**RE: CJ Dens Subdivision Review Comments Response (SUB20-02)**

This letter is written as a response to the comments received on March 9, 2021 for the CJ Dens Subdivision (SUB20-02). I have included with comment, with AKS's response below.

**TRACT K ADJUSTMENT EXHIBIT****EXHIBIT  
A**

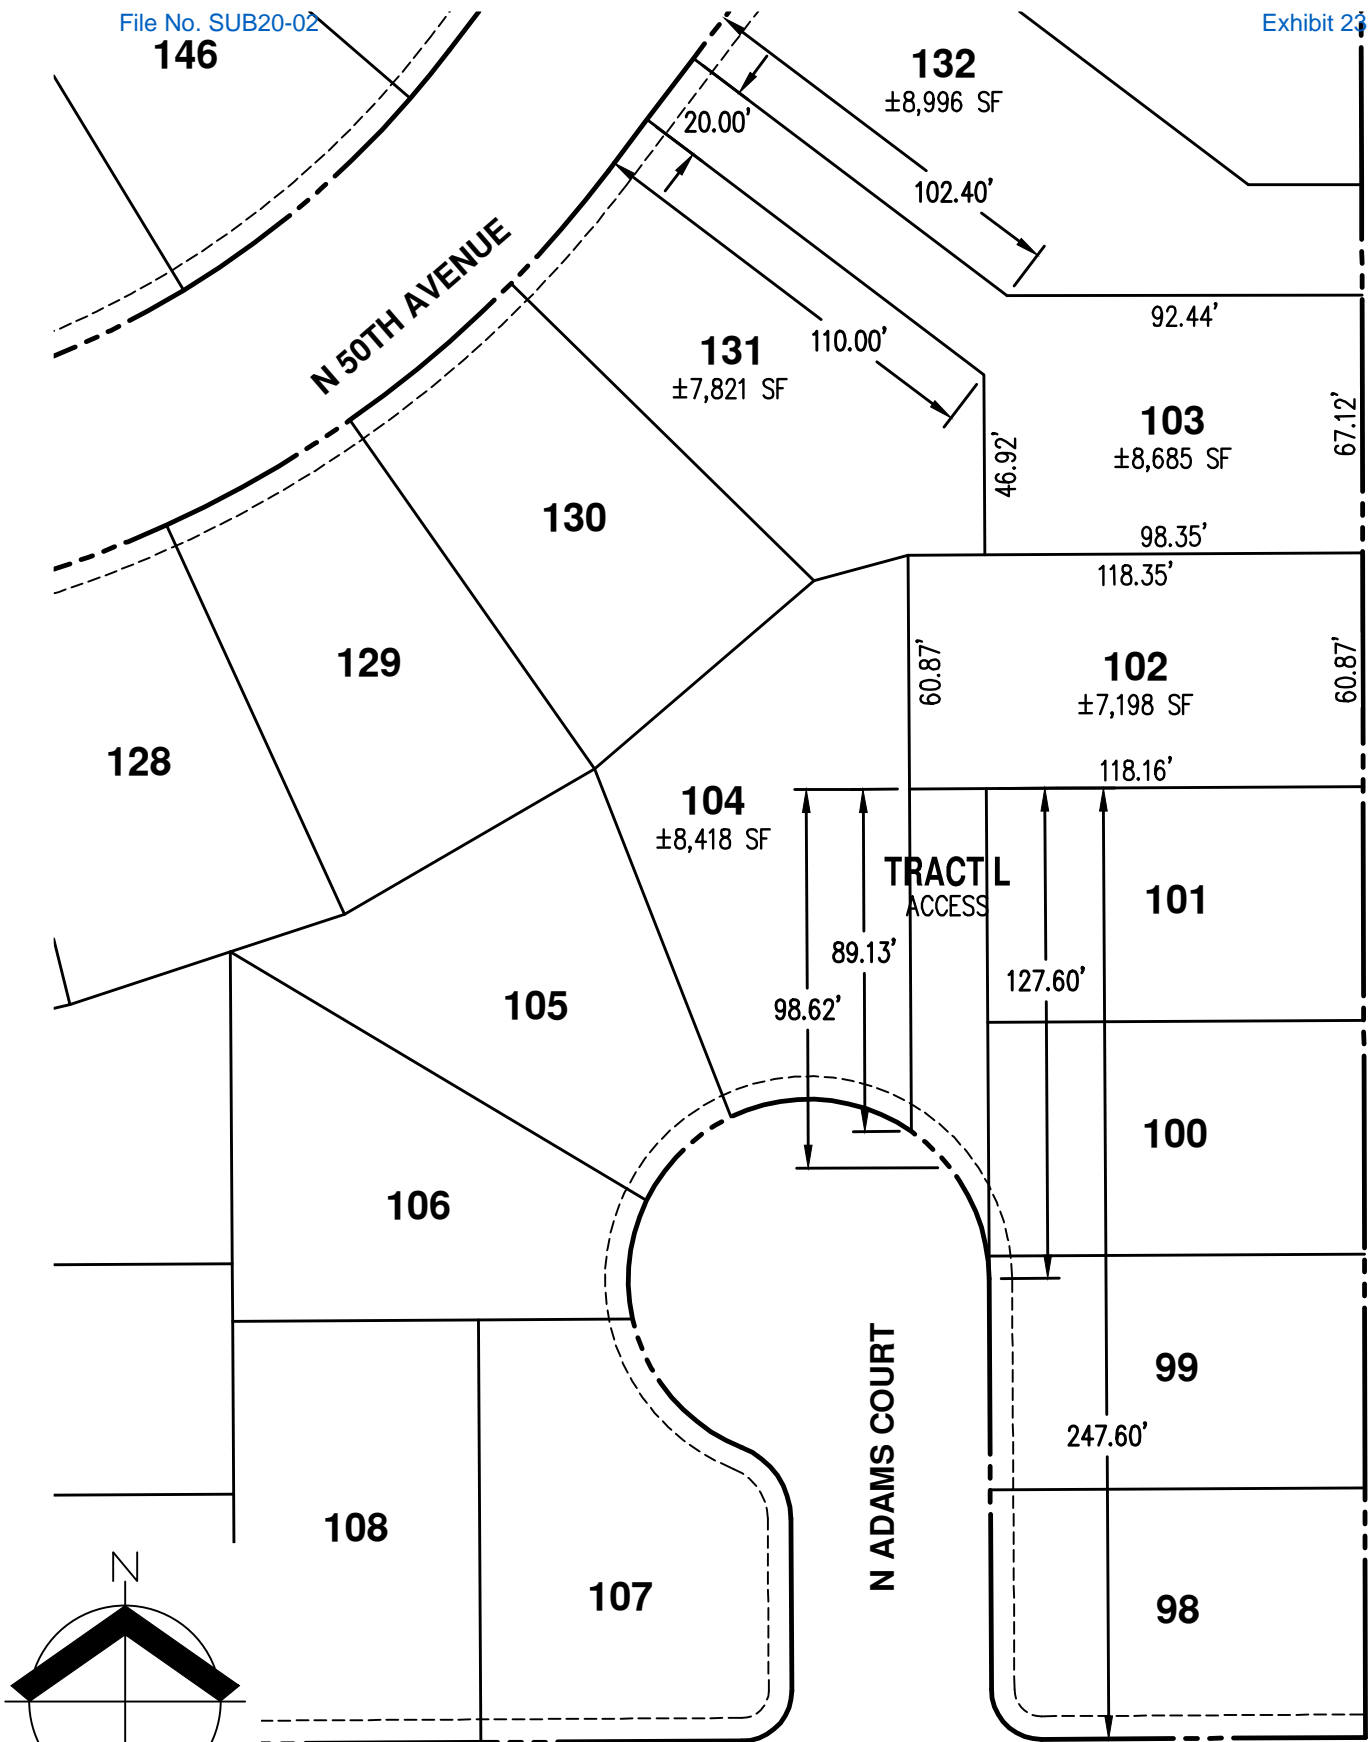
15. Dead-end turnarounds required on private roads located in Tract K (Lots 85-89), Tract L (Lots 98-103), and Tract M (Lots 109-112). For Tract M, the applicant is encouraged to work with staff on other mitigation measures.

**Response:** The plans will be updated to show a turnaround for Tract K. Lot 103 will become a flag lot accessing from N 50<sup>th</sup> Avenue and Tract L will end at the south side of Lot 102. Therefore, Tract L is less than 150 feet. Tract M has been shortened to less than 150 feet, with access still provided to all lots on the tract. Exhibits were provided to the City showing the updates are included with this letter. All houses in the development are sprinklered and all homes can be reached by a 150-foot hose run from the end of each tract.

EXHIBIT D - T-3 TRAIL LOCATION

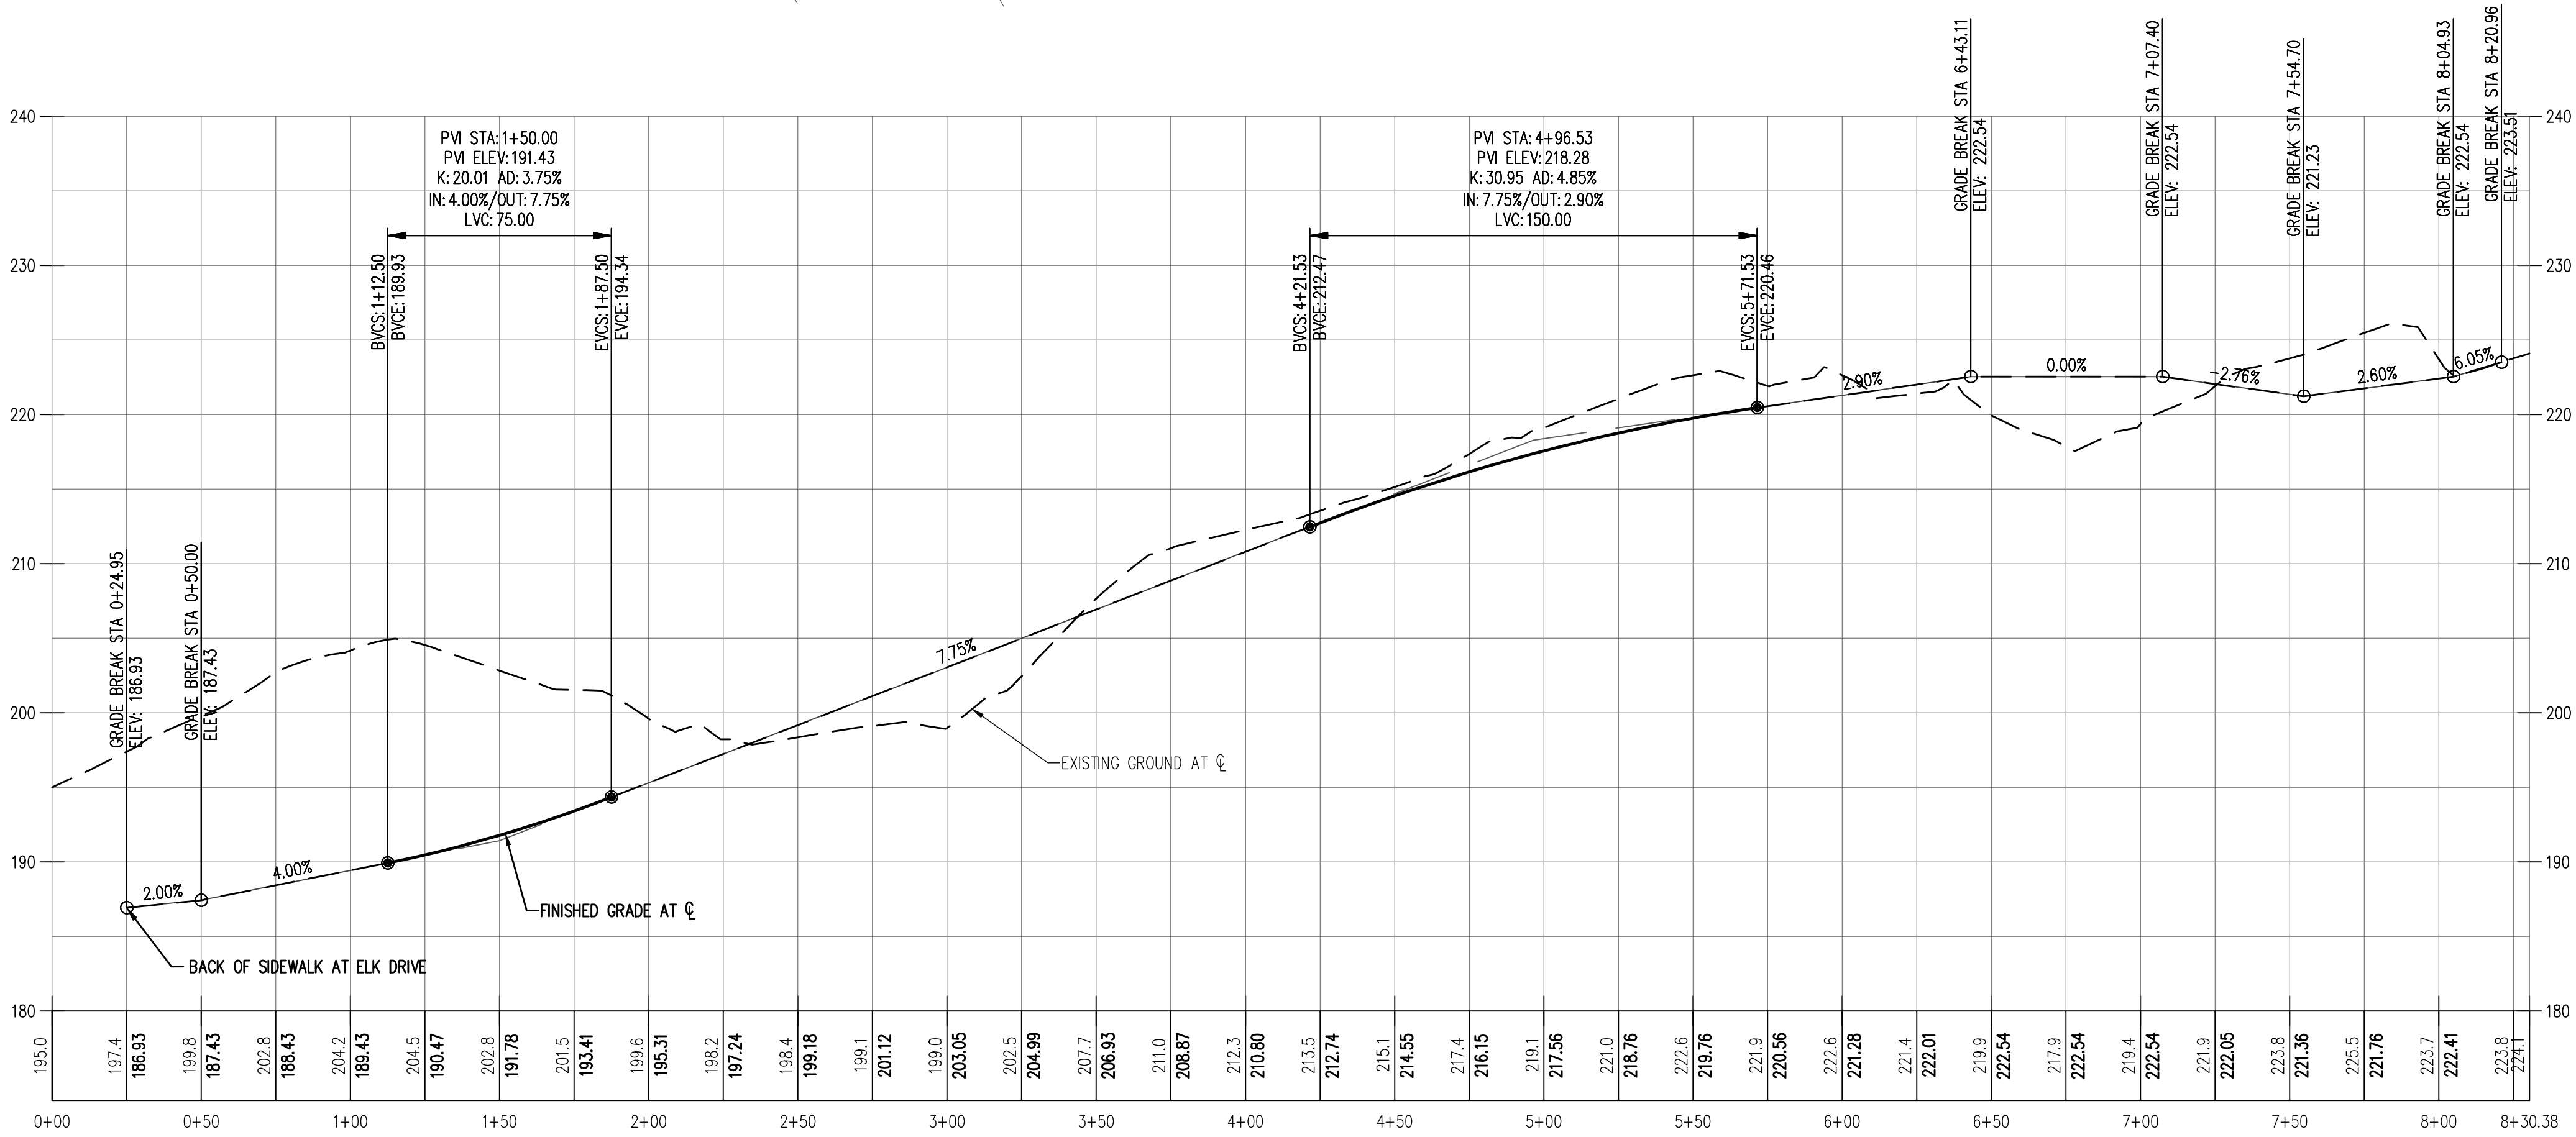
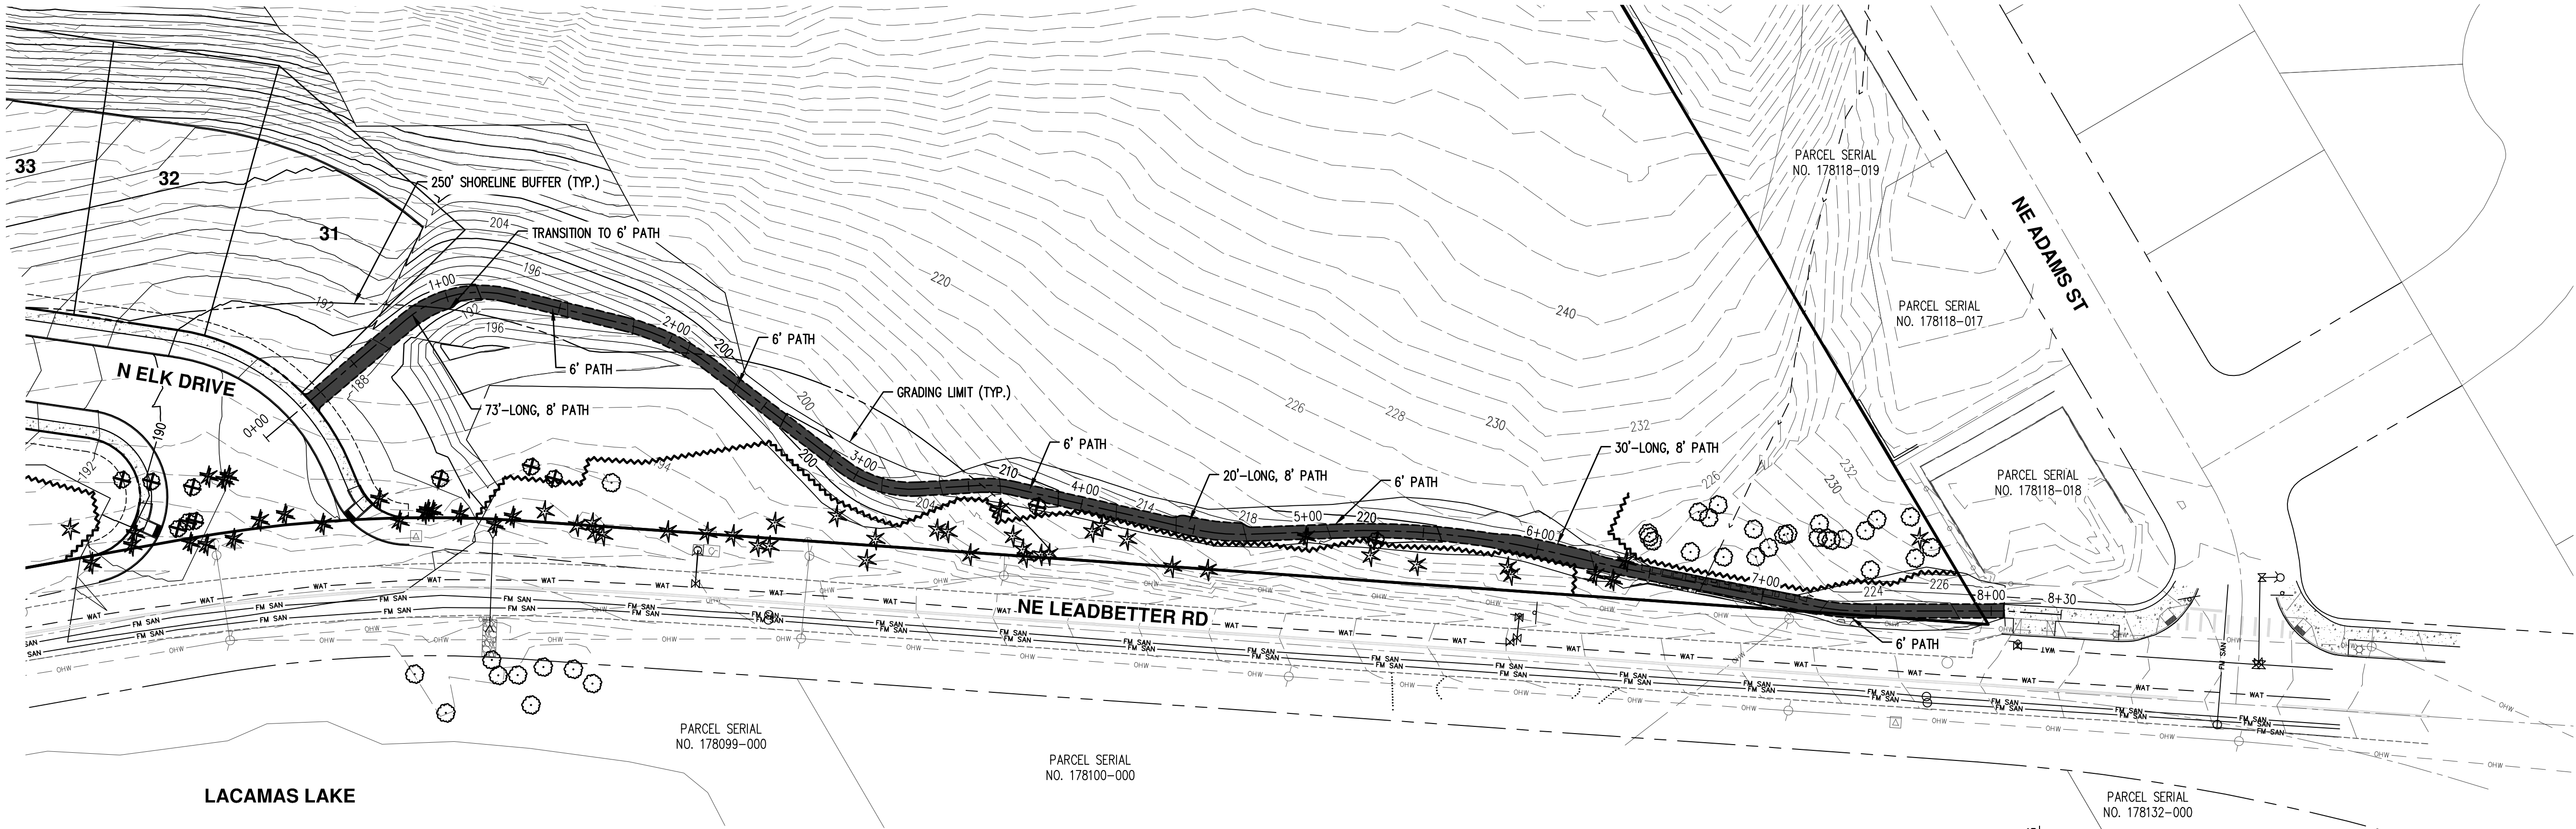
8. T-3 Regional Trail requires a 12-ft wide pave trail per the City's Parks Recreation and Open Space (PROS) plan. However, staff finds a 6-ft. wide paved trail, consistent with the local trail requirements in the PROS plan, is acceptable to help reduce tree removal and grading impacts. Keep in mind the Parks Department will have the final input on trail requirements.

**Response:** Plans will be updated to a 6-foot gravel trail. With portions widened to 8-foot and turnaround at the west end as requested by the Parks Department.
